CITY PLANNING COMMISSION

A. Special Permit to add drive-up window service to an existing 2,400+ sq. ft. 70 seat Dairy Queen restaurant on 0.33+ developed acres in the General Commercial (C-2) zone.

LOCATION: 480 and 496 El Camino Avenue

APPLC. NO. P88-126 MEETING DATE May 12, 1988 ITEM NO. 16

SITE PLAN

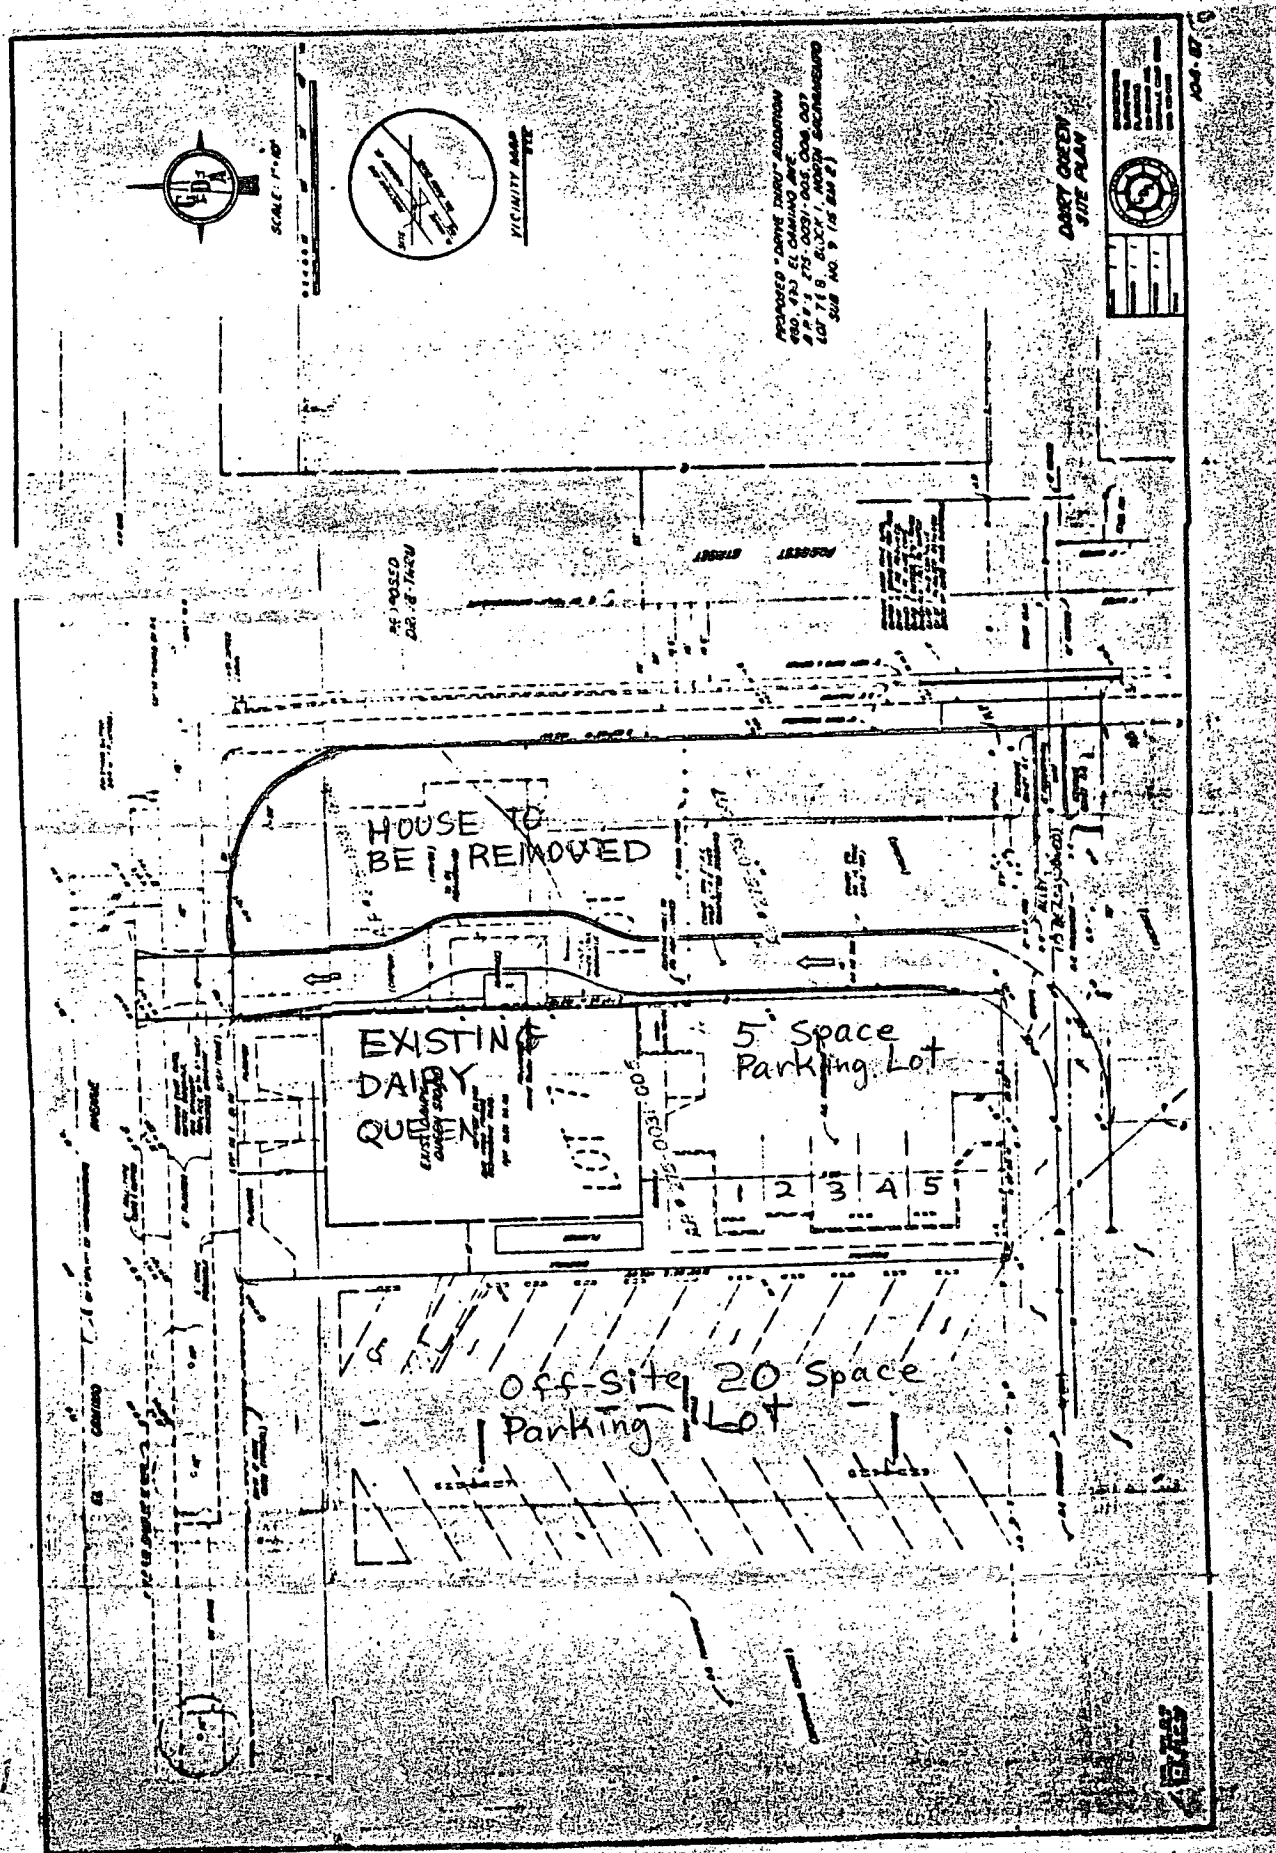
1. Drive-up aisle - Staff reviewed the site plan and notes that the proposed drive-up lane is proposed adjacent to the building except for a ~~job~~ jog at the drive-up window. The east elevation of the building is constructed of brown concrete block with no interest or variation. Staff discussed with the City Traffic Engineer the drive-up window jog and determined a five foot wide landscape planter adjacent to the east elevation would be more appropriate ~~with~~ with the drive-up lane going straight. (Refer to staff modified site plan.) Staff recommends the drive-up lane be moved five feet to the east and a 5 foot wide landscape strip with tall, vertical shrubs be planted with living ground cover adjacent to the east elevation. (Corrected by Staff)

4. Public Address System: The drive-up window requires a public address system and reader board. Neither are shown on the site plan. A revised site plan shall show the location of the menu board and loudspeaker. The speaker shall be directed and adjusted in volume so that it will not be audible offsite.

7. Drive Up Lane: City Traffic Engineering notes that traffic on El Camino Avenue is heaviest during commute hours and that drive-up window customers may have difficulty exiting into the west bound traffic. Staff recommends that a right-turn only sign be installed at the exit so that cars can exit east bound and not obstruct traffic west bound on El Camino.

The stacking distance for automobiles is recommended at ten spaces as per the City Traffic Engineer. The revised site plan shall show a minimum of one car at the pick-up window, four between the pick-up window and reader board and speaker, one space at the reader board and four spaces behind the one at the reader board. The vehicle length used for calculations is 20 feet.

No lighting plans were prepared for the parking lot or drive-up lane. Staff recommends that the revised site plan show all sources of illumination and that lighting be shielded or directed onsite to not glare or reflect offsite. Low profile ground level lights are recommended. (Correction by Staff)

17. The drive-up lane shall be relocated five feet to the east to allow a five foot landscape planter adjacent to the east elevation. A mix of vertical and bushy shrubbery shall be planted adjacent to the wall. ~~No 13' or 14' tree drive-up aisle shall be allowed.~~ (Corrections by Staff)

STAFF MODIFIED SITE PLAN

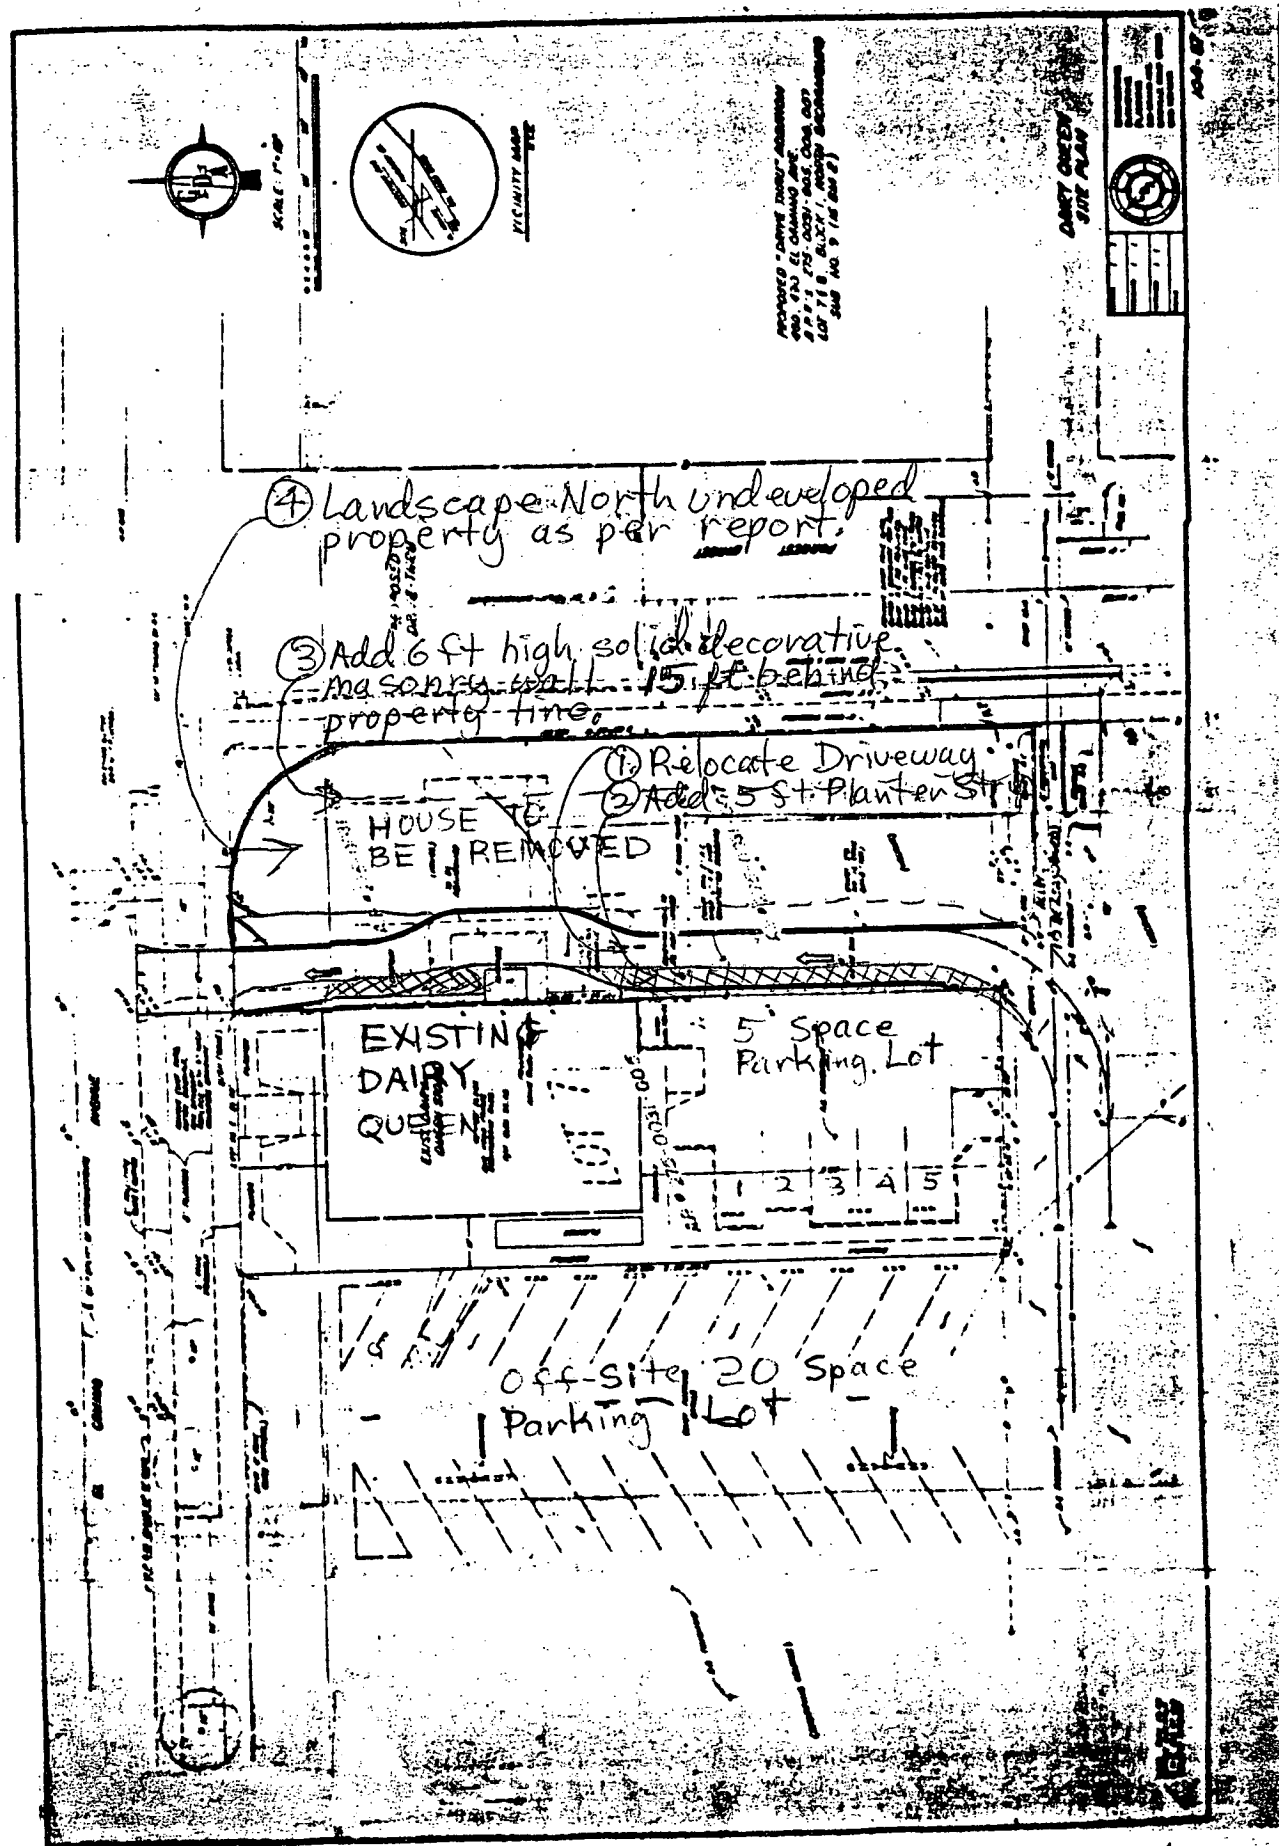
2. Fencing and Wall: Staff notes that approximately 30 feet of unimproved area lies between the drive-up lane and Forrest Street. City Code requires a wall where commercial uses abut residential zones or uses. During hearings in 1985 on the variance request for offsite parking, neighbors along Forrest Street expressed concern over the impact vehicles may have exiting Dairy Queen over the alley. Noise, exhaust and headlight glare were identified as intrusions into the residential area.

Staff has proposed that a 15 foot wide landscape buffer be installed the length of Forrest Street. In this landscape strip, a mix of five and 15 gallon evergreen trees on 20 foot centers is recommended. Living ground cover of lawn or ivy is recommended. No rock, gravel or bark mulch is to be used as ground cover. Behind the 15 ft. setback, staff recommends construction of a six foot high solid decorative masonry wall. The wall's height is to be reduced to three feet within the front yard setback of 16-1/2 feet from El Camino Avenue. Where the wall intersects the existing alley, either a pedestrian opening or gate is to be constructed which observes the underground utility easements. The wall shall extend westward along the south edge of the alley right-of-way the width of the Dairy Queen parcel. The wall will provide security and eliminate trespassing into neighboring yards.

3. Drive up Lane Landscaping: With the proposed 15 foot landscape setback and wall adjacent to Forrest Street, a remaining 15 foot wide strip remains adjacent to the east side of the drive-up lane. Staff has reviewed this with the applicant and has determined lawn or ground cover with trees and shrubbery is appropriate. All landscaped areas are to ~~be irrigated~~ be irrigated. With the landscaping and six foot wall along the Forrest Street frontage, staff has determined that an adequate buffer from the residential neighborhood is established. (Corrected by Staff)

18. Landscape plans shall show living ground cover over the entire area from Forrest Street to the drive-up aisle. In the 15 foot landscape area, a mix of 5 and 15 gallon evergreen trees on 20 foot staggered centers is required. Berming ~~every~~ two to three feet is also recommended. (Correction by Staff)

ELEVATIONS

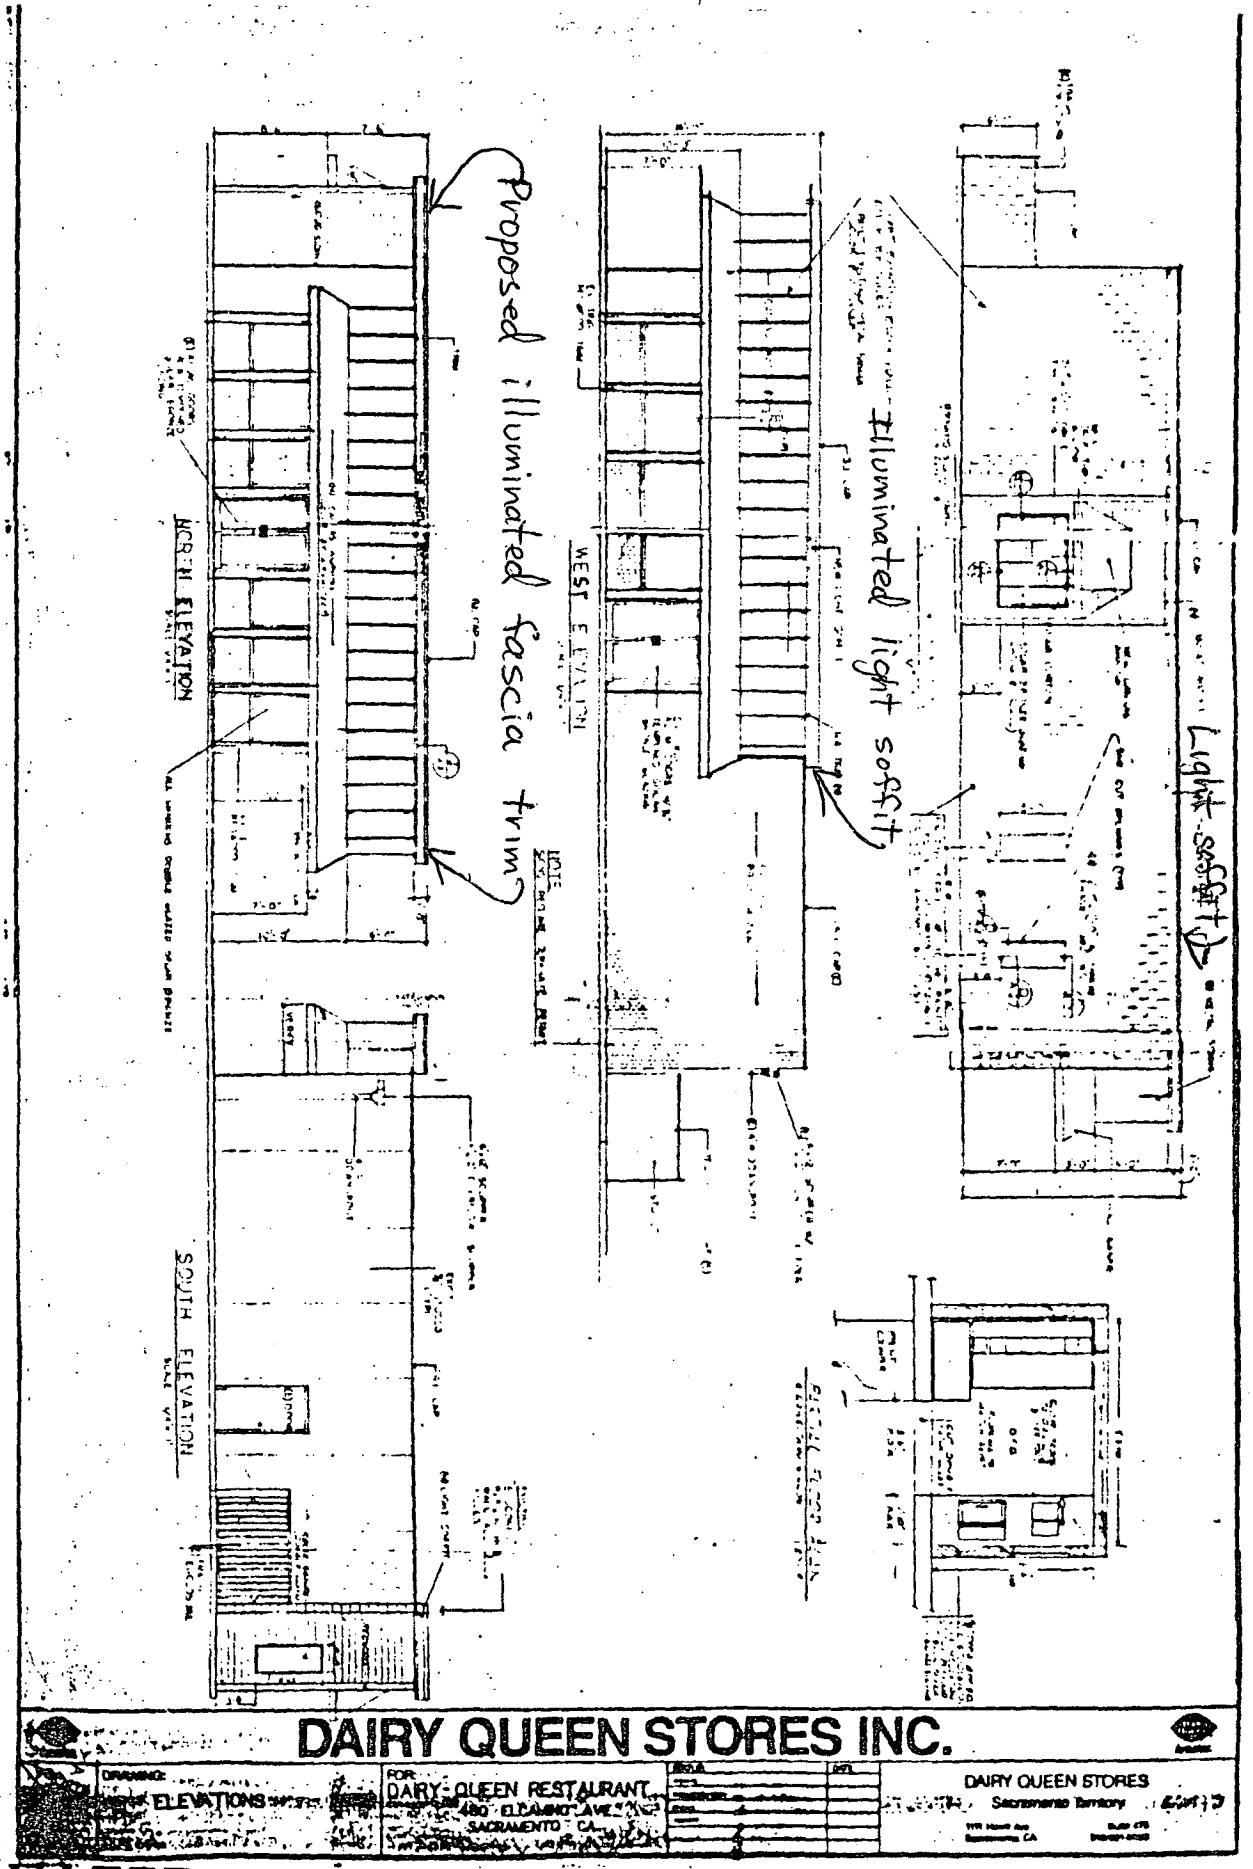
The applicant's elevations propose to modify the approved elevations in 1985. The addition of a canvas awning is proposed along the north and west elevations. Staff ~~does not support~~ supports locating an awning into the front building setback along El Camino Avenue. Red is the color. No color of the awning is proposed. Staff does not support the decorative awning since the building already projects close enough to property lines. No colors are indicated for either the awning or canopy. Staff does not support the structure or possible incompatible colors such as bright red or orange.

The applicant proposes an illuminated soffit along the top roof line on the east, north and west elevations. The soffit lighting outlines the building, however, the light shines down against the structure. ~~and his not allowed according to the City Sign Ordinance. Additionally, the lighting will reflect back onto residentially zoned or used property.~~
No glare is anticipated to reflect offsite from the soffit lighting.

The east elevation proposes to have two saw cut windows and the drive-up window added. Otherwise, the wall remains stark and uninteresting. Staff has recommended a five foot wide landscape strip adjacent to the east elevation with shrubbery which will break up the lower portion of the wall. Staff recommends that a decorative trim element compatible with the north and west elevations be continued around to the east elevation along the top half of the wall area. The applicant has agreed to provide a decorative trim element on the east elevation.

This revised elevation shall be reviewed and approved by the City Design Review Coordinator prior to submittal for building permits. (Corrections by Staff)

20. Detailed elevations shall be revised to ~~delete the canvas awning and soffit~~ lighting. ~~Elevations for the east view shall have~~ extend a decorative trim element carried over from the west and north elevations. Elevation revisions are to be reviewed by the Planning Director and approved prior to issuance of building permits. (Corrections by Staff)
21. One detached monument type sign shall be allowed. Height of the sign shall not exceed six feet and indirect ~~external~~ lighting shall be used. (Correction by Staff)
